<b>REFERENCE:</b>	<b>TSB:</b> 08-131-24 REV. A <b>GROUP:</b> 08 - Electrical	<b>Date:</b>	May 29, 2024	<b>REVISION:</b>	08-131-24
<b>VEHICLES AFFECTED:</b>	<b>2021 (GU) Alfa Romeo Stelvio</b> This bulletin applies to vehicles equipped with a Global Telematics Box Module (Sales Code RDG) and SiriusXM Guardian-Included Trial (B) (Sales Code RT1).	<b>MARKET APPLICABILITY:</b>			
		<input checked="" type="checkbox"/> NA <input type="checkbox"/> MEA <input type="checkbox"/> SA <input type="checkbox"/> IAP <input type="checkbox"/> EE <input type="checkbox"/> CH			
<b>CUSTOMER SYMPTOM:</b>	<b>The customer may also experience one or more of the following:</b> <ul style="list-style-type: none"> <li>• Outdated vehicle data on customer's mobile app.</li> <li>• Connected Services maintenance popup displayed on the radio screen.</li> <li>• Connected Services battery maintenance popup displayed on the radio screen.</li> </ul>

<b>CAUSE:</b>	TBM Software

This bulletin supersedes Technical Service Bulletin (TSB) 08-131-24, date of issue May 25, 2024, which should be removed from your files. All revisions are highlighted with **\*\*asterisks\*\*** and include an updated LOP Number.

**Fig. 1**  
Battery Of Connected Services Messages

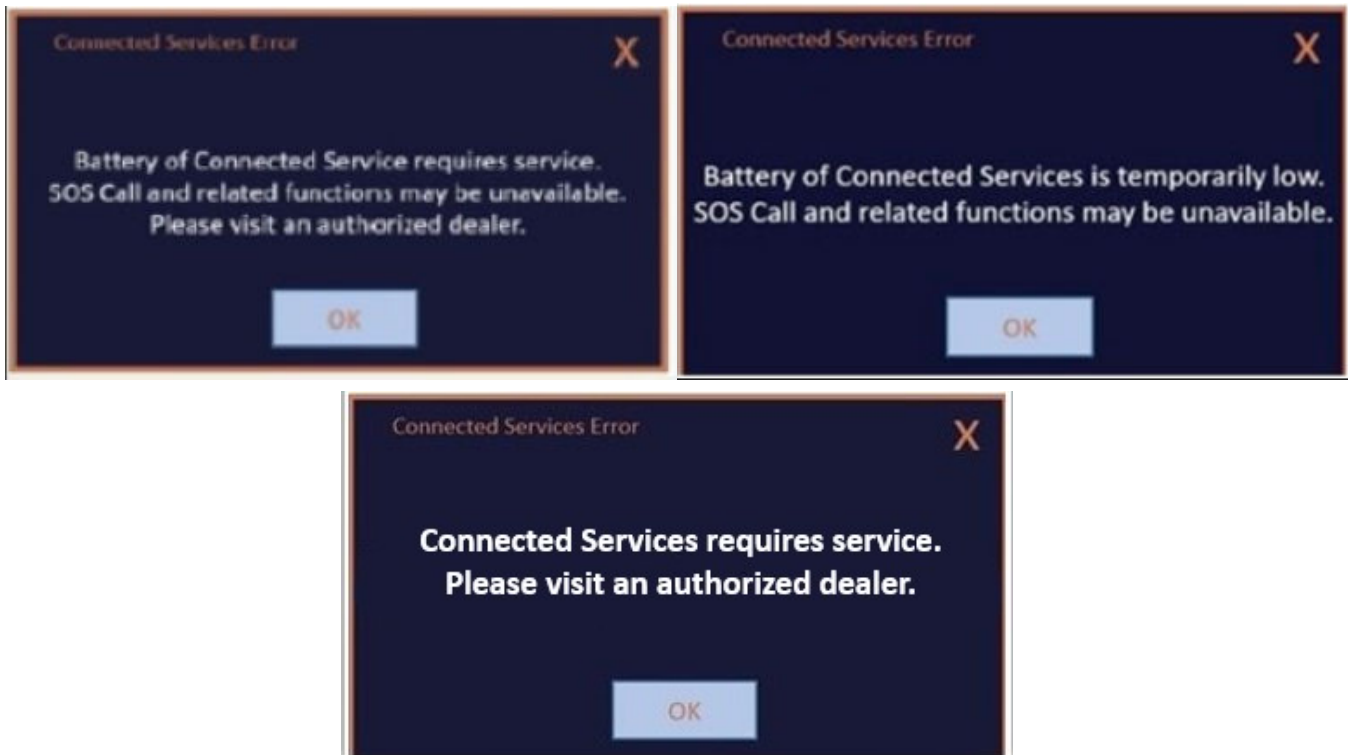
Message display on the radio screen, "Uconnect Box requires service. Please visit an authorized dealer." [Fig. 1.](#)

**NOTE: "Uconnect Box requires service." message can be triggered by different reasons. For an issue on a new vehicle recently switched to customer mode, please follow the New Vehicle Preparation procedure to resolve the issue. For the customer vehicle with intermittent concerns, please check the TBM, antenna and instrument panel harness connections.**

This bulletin involves reprogramming the TBM with the latest available software.

1. Reprogram the TBM with the latest software. If issues arise when flashing a module using the wiTECH Diagnostic Application, please submit a ticket to the Helpdesk. The helpdesk can be found within the Help menu.
2. Clear all DTCs that may have been set in any module due to reprogramming. The wiTECH application will automatically present all DTCs after the flash and allow them to be cleared.
